Model: MET-C1cde	Date: 18-Jun-13	No.: RD149007
------------------	-----------------	---------------

Subject: Firmware Release Note: Java VM v11 UpdateTool (METC1EXe)		Prepared by: N. Yoshida	
From: 1st Tech Service Sect., MFP/Printer Tech Service Dept.			
Classification:	<input type="checkbox"/> Troubleshooting	<input type="checkbox"/> Part information	<input type="checkbox"/> Action required
	<input type="checkbox"/> Mechanical	<input type="checkbox"/> Electrical	<input type="checkbox"/> Service manual revision
	<input type="checkbox"/> Paper path	<input type="checkbox"/> Transmit/receive	<input type="checkbox"/> Retrofit information
	<input type="checkbox"/> Product Safety	<input checked="" type="checkbox"/> Other (Firmware)	<input checked="" type="checkbox"/> Tier 2

This RTB has been issued to announce the firmware release information for the **Java VM v11 Update Tool (METC1EXe)**.

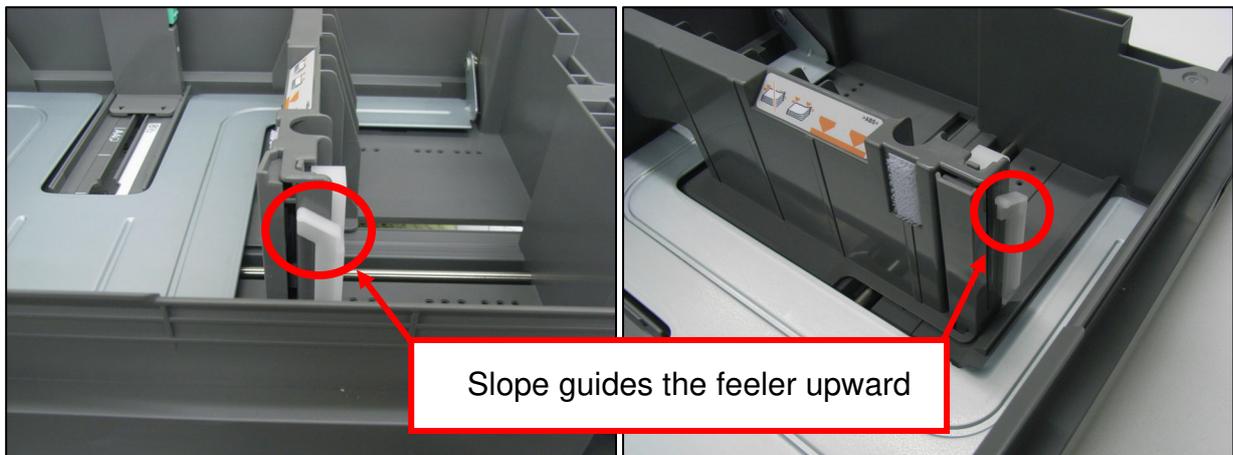
A feeler guide was added to reduce the chances that the paper stack will contact the feeler.

Note: When the tray is closed, the guide pushes the paper end feeler up before the paper stack has a chance to contact it.

Photo 1 (Level 1):

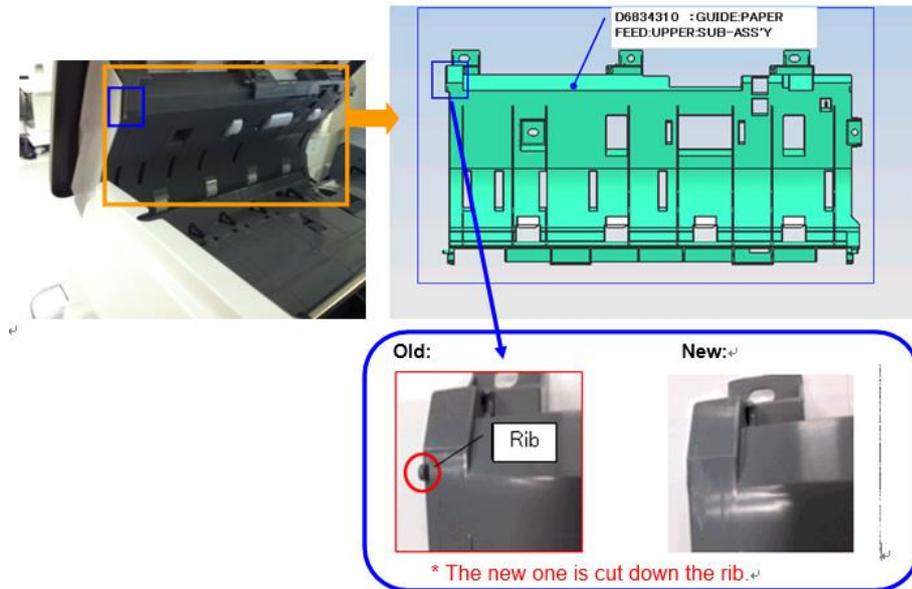
Model: MET-C1d		Date: 06-Feb-14	No.: RD149061a
Production level	Change		
Level 1	The rib on the SPDF guide plate was deleted (see Photo 1).		
Level 2: Permanent countermeasure	The rib was moved as shown in Photo 2 to provide a wider space through which the original can pass.

Before change

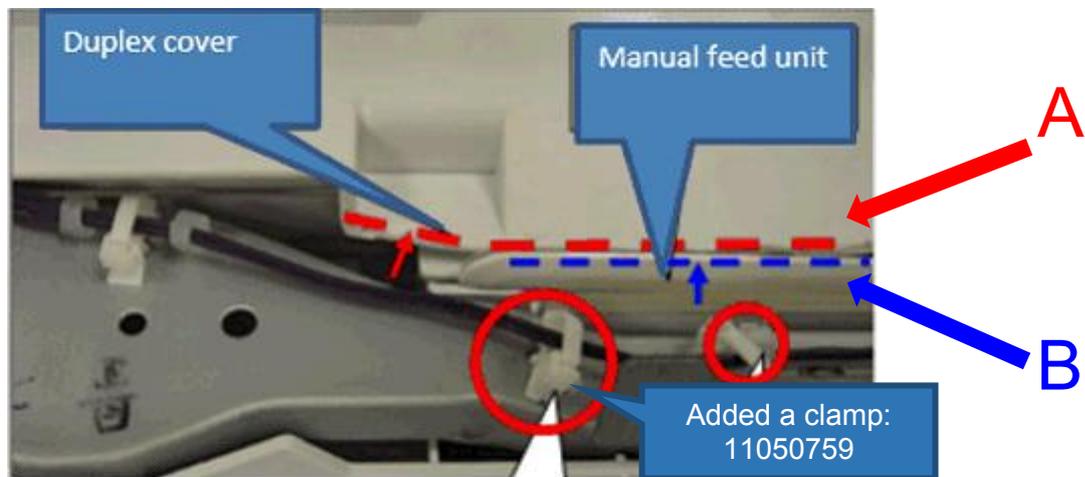
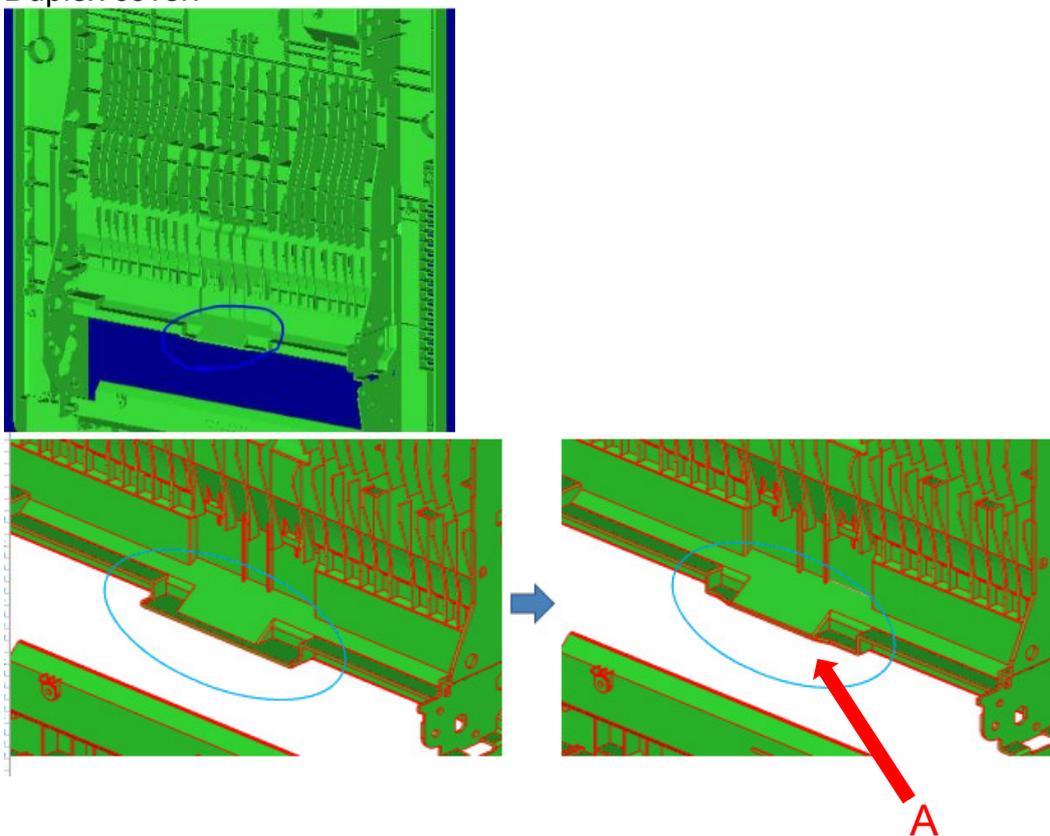
Manual feed unit and duplex cover need to be replaced together.

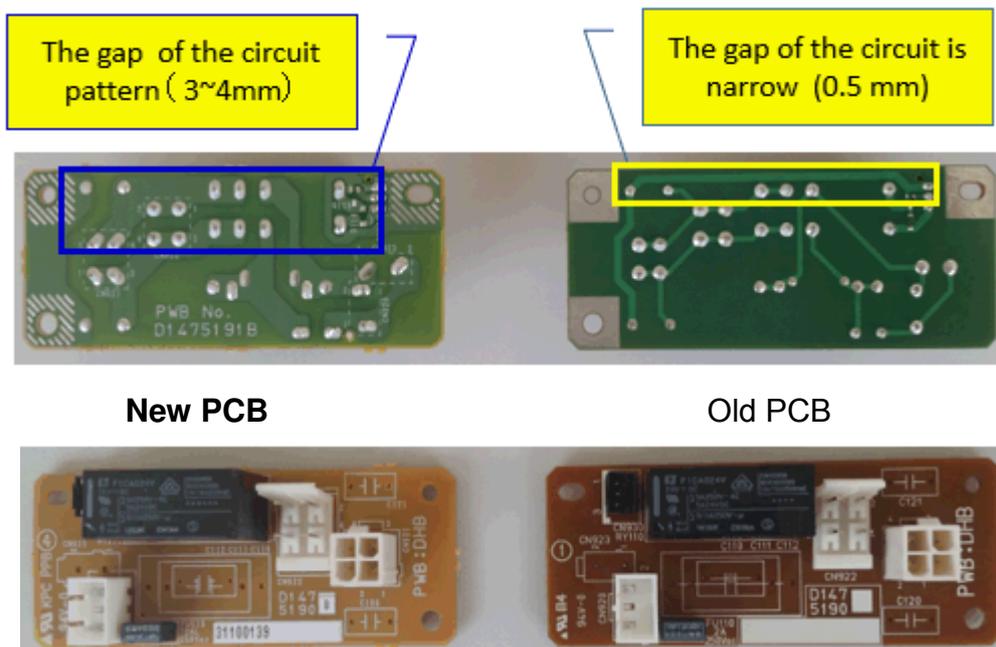
Changed: The design of the PCB: DHB (relay board) was changed.

Reason: To further protect against shorts triggered by high voltage, which can happen if the lines on the PCB are too close to one another.

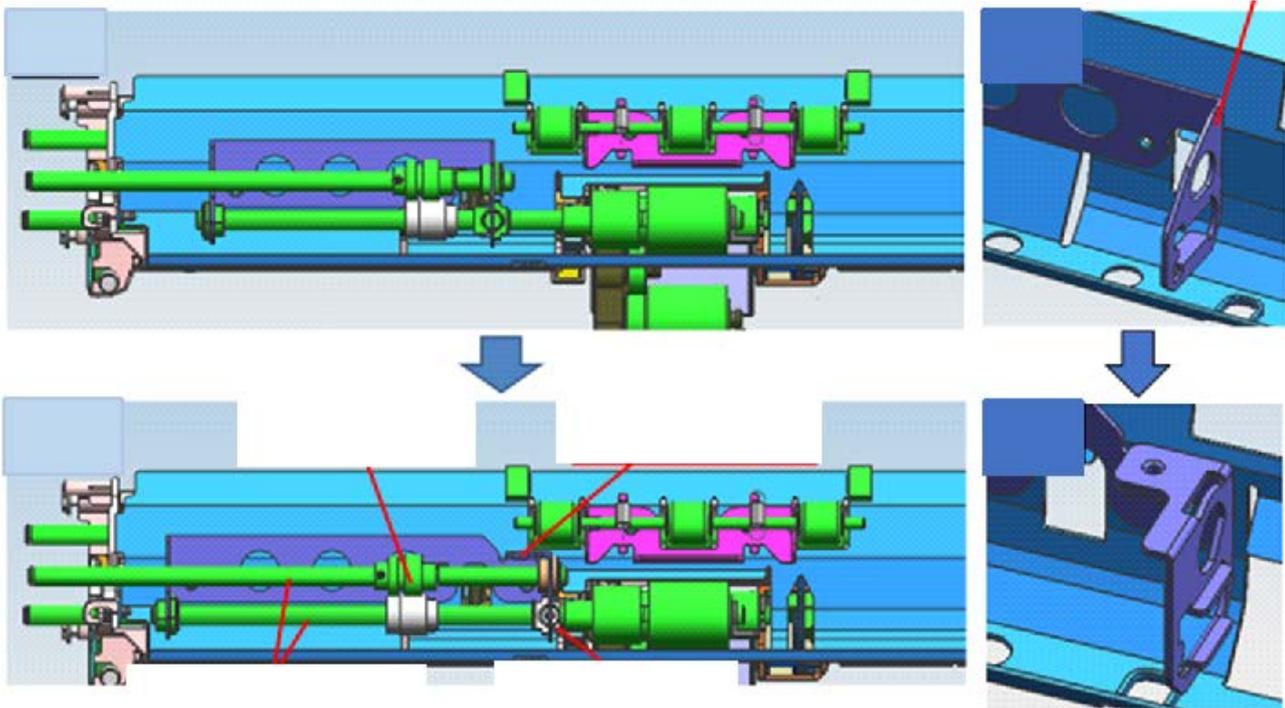
Change 4: There are no protruding parts to hold the gear. An e-ring added to stop the gear in position, and a groove added to the shaft for the e-ring.
